Site Accessibility Evaluation
Americans with Disabilities Act
Title II (Public Services: State and Local Government)

GENOVEVA CHAVEZ COMMUNITY CENTER
3221 Rodeo Rd
Santa Fe, NM 87507

Report Date: 02/03/2025

Finding: 2

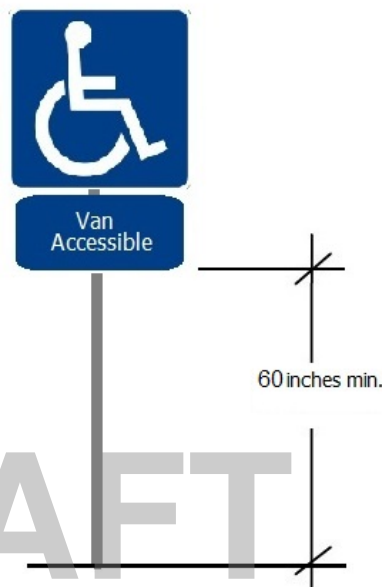
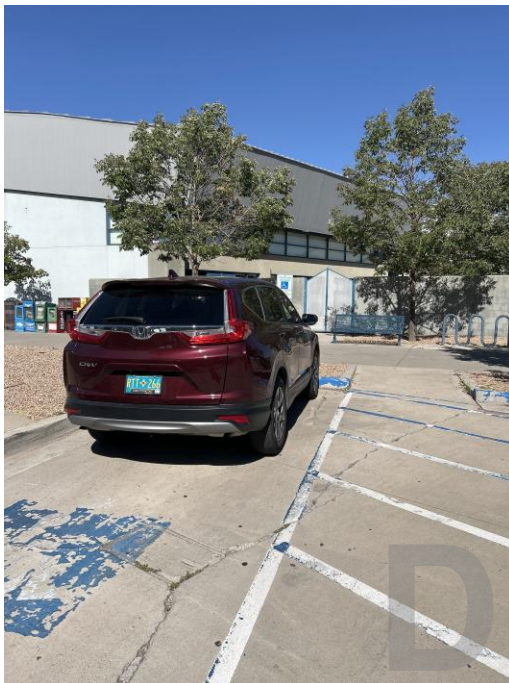
The parking sign is mounted too low.

Identification sign for accessible parking space is not mounted at required height.

Remount identification parking signage at 60 inches min. from ground to bottom most of the sign.

Finding: 5

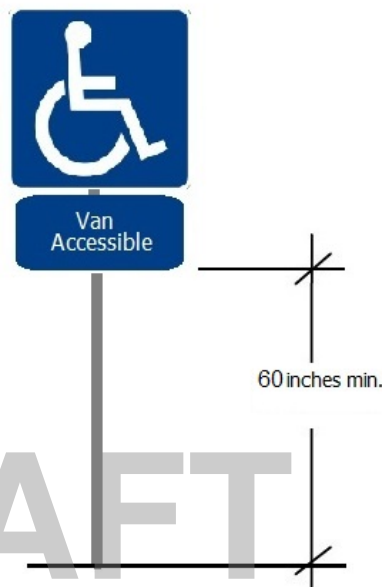
The parking sign is mounted too low.

Signage is less than 60 inches from bottom of edge of sign to ground.

Install signage at required height.

Finding: 6

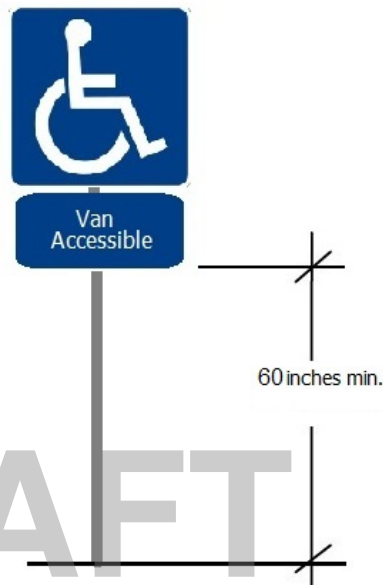
The required parking signage is missing.

Signage is missing.

Install signage.

Finding: 7

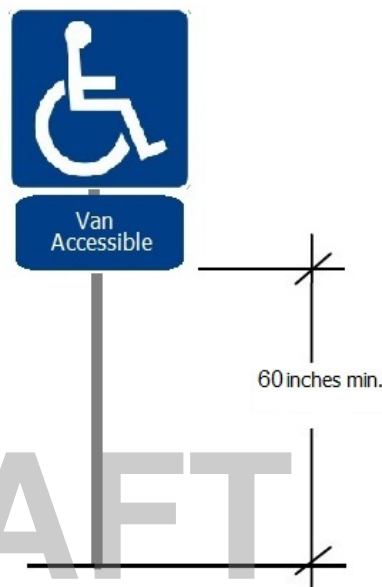
The parking sign is mounted too low.

Identification sign for accessible parking space is not mounted at required height.

Remount identification parking signage at 60 inches min. from ground to bottom most of the sign.

Finding: 9

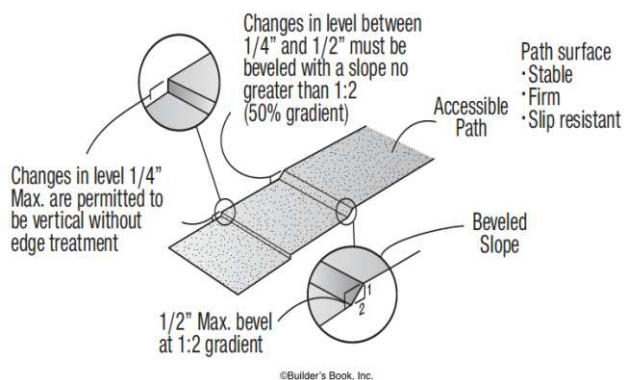
The accessible route contains loose gravel and/or surface materials that do not provide for a stable, firm slip resistant surface.

Finding: 11

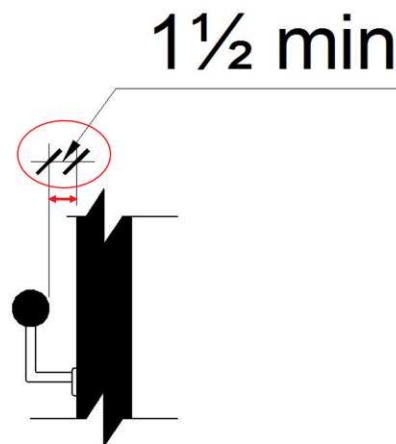
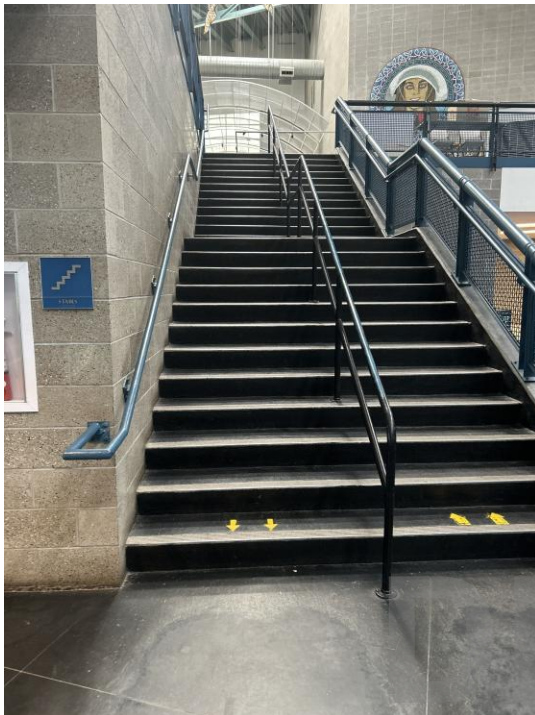
The handrails are not spaced correctly from the wall.

Current clearances measure 2 inches to 4.25 inches.

Remount existing handrails.

Finding: 30

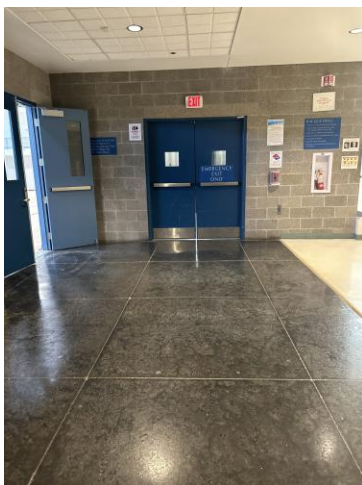
The tactile EXIT sign is missing at the door.

Signs for people with vision impairments are not provided.

Provide raised letter/braille "Exit Route" sign at door.
